SUBJECT: LIMERICK GENERATING STATION, UNIT 2 (TAC NO. M96390)

AMENDMENT TO FACILITY OPERATING LICENSE

Amendment No. 80
License No. NPF-85

SAFETY EVALUATION BY THE OFFICE OF NUCLEAR REACTOR REGULATION
RELATED AMENDMENT NO. 80 TO FACILITY OPERATING LICENSE NO. NPF-85
PHILADELPHIA ELECTRIC COMPANY
LIMERICK GENERATING STATION, UNIT 2
DOCKET NO. 50-353

MINIMUM REACTOR VESSEL METAL TEMPERATURE VS. REACTOR VESSEL PRESSURE
 FIGURE 3.4.6.1-1

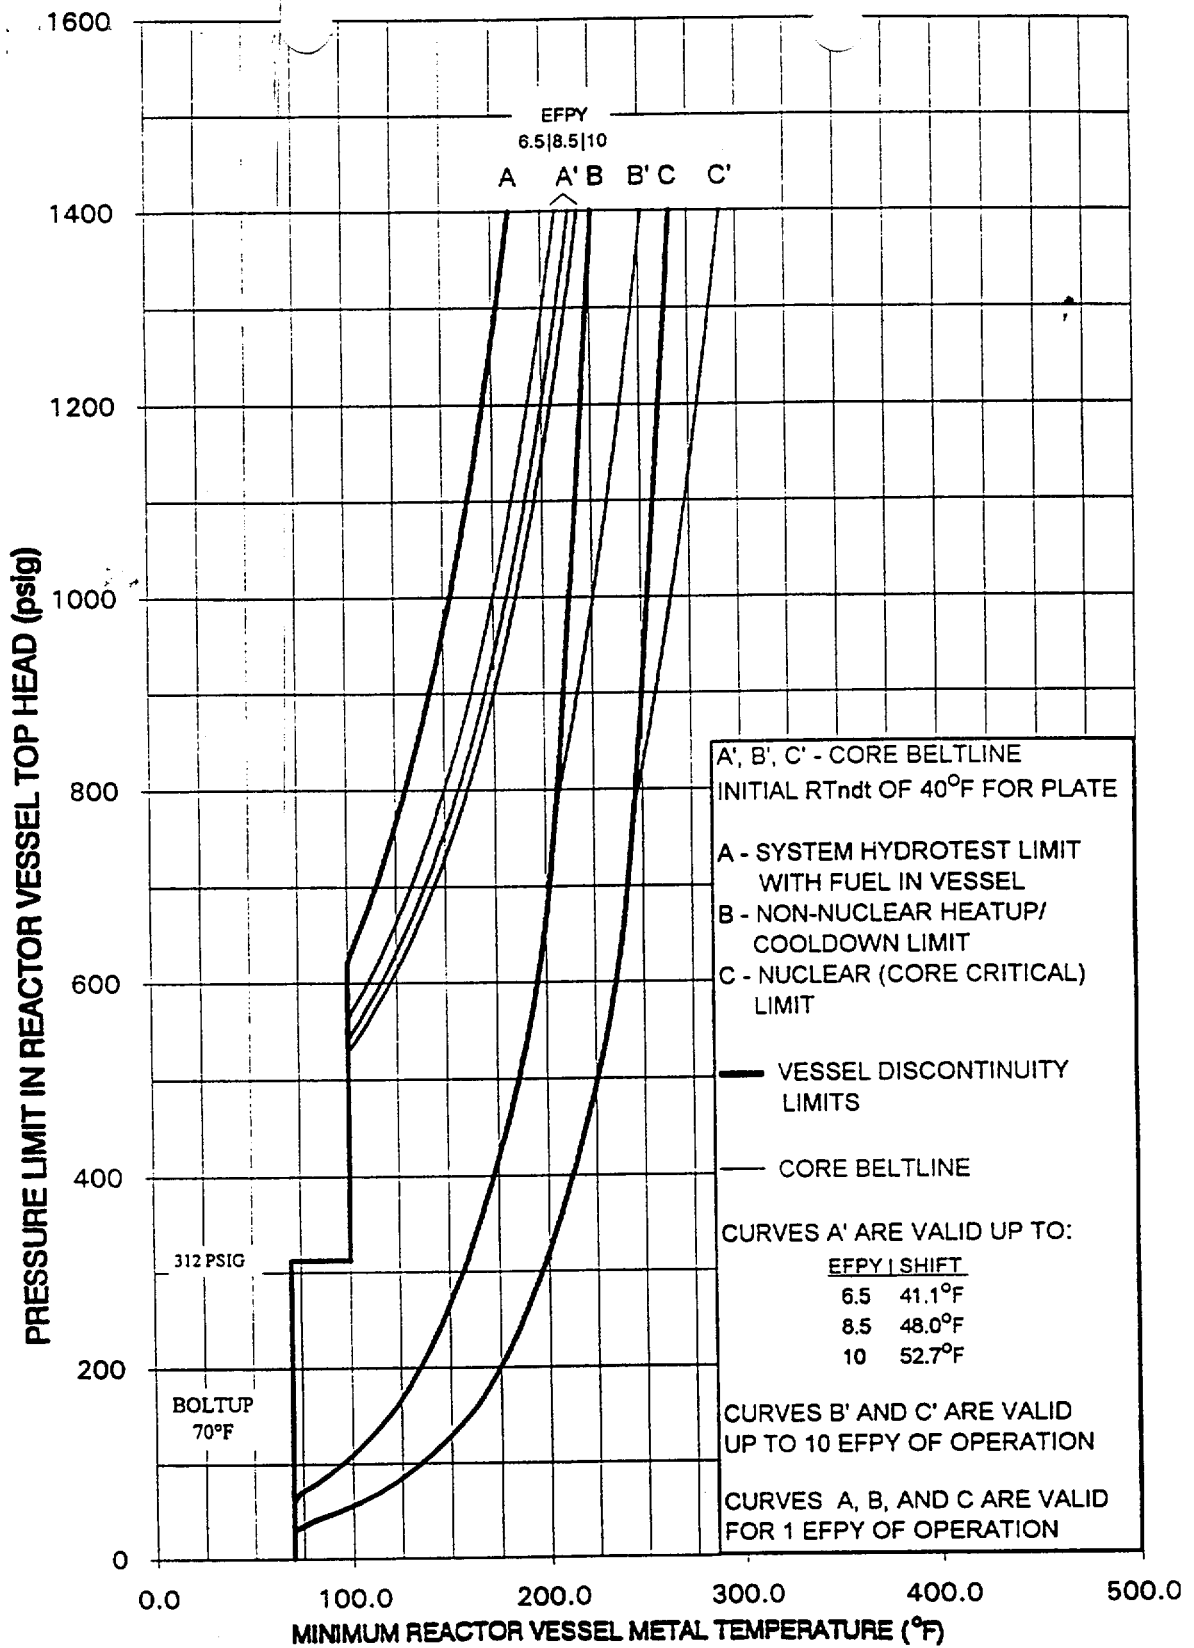
This amendment revises TS Section 3/4.4.6 (i.e., Figure 3.4.6.1-1) to reflect the addition of two hydrotest curves, effective for 6.5 and 8.5 Effective Full Power Years (EFPY), to the existing Pressure-Temperature Operating Limit (PTOL) curves for LGS Unit 2.

The pressure-temperature limit lines shown in Figures 3.4.6.1-1, curves C, and C', and A and A', for reactor criticality and for inservice leak and hydrostatic testing have been provided to assure compliance with the minimum temperature requirements of Appendix G to 10 CFR Part 50 for reactor criticality and for inservice leak and hydrostatic testing.

The staff evaluated the effect of neutron irradiation embrittlement on the limiting beltline material in the Limerick 2 reactor vessel. The amount of irradiation embrittlement was calculated in accordance with RG 1.99, Revision 2. The two hydrotest curves of 6.5 and 8.5 EFPYs, which are to be added to the P/T limits of Limerick 2, were derived using the same material parameters and loading information as those of the existing hydrotest P/T limits of 10 EFPYs. The only difference between the added curves and the existing one is the different fluence values as reflected by their different EFPY values. The limiting material with the highest adjusted reference temperature (ART) at 6.5 and 8.5 EFPYs for Limerick 2 is plate 14-2 (heat number B3416-1), which has 0.14% copper (Cu), 0.65% nickel (Ni), and an initial RT_{ndt} of 40°F.

The staff calculated the highest ART for both EFPYs. For plate 14-2 at 6.5 EFPY, the staff calculated the ARTs to be 79.0°F at 1/4t, and 64.4°F at 3/4t. The staff used a fluence of $2.42E17$ n/cm² at 1/4t and $1.15E17$ n/cm² at 3/4t. At 8.5 EFPY, the ARTs were calculated to be 86.0°F and 69.2°F using fluence

The licensee calculated that the RT_{ndt} would shift upwards by 41.1°F for 6.5 EFPY and 48.0°F for 8.5 EFPY from an initial RT_{ndt} of 40°F. Therefore, the respective ARTs would be 81.1°F and 88.0°F. These agree well with the staff's calculated values of 79.0°F and 86.0°F, considering that the staff estimated the fluence values for 6.5 and 8.5 EFPYs based on a linear interpolation. Substituting these ARTs into equations in SRP 5.3.2, the staff verified that the added P/T limits for hydrotest meet the beltline material requirements in Appendix G of 10 CFR Part 50.

The staff concludes that the two added P/T limits for the reactor coolant system hydrotest are valid through 6.5 and 8.5 EFPY because the limits conform to the requirements of Appendix G of 10 CFR Part 50. The P/T limits also satisfy Generic Letter 88-11 because the licensee used the method in RG 1.99, Revision 2 to calculate the ART. Hence, the proposed P/T limits and their corresponding Bases may be incorporated into the Limerick 2 Technical Specifications.
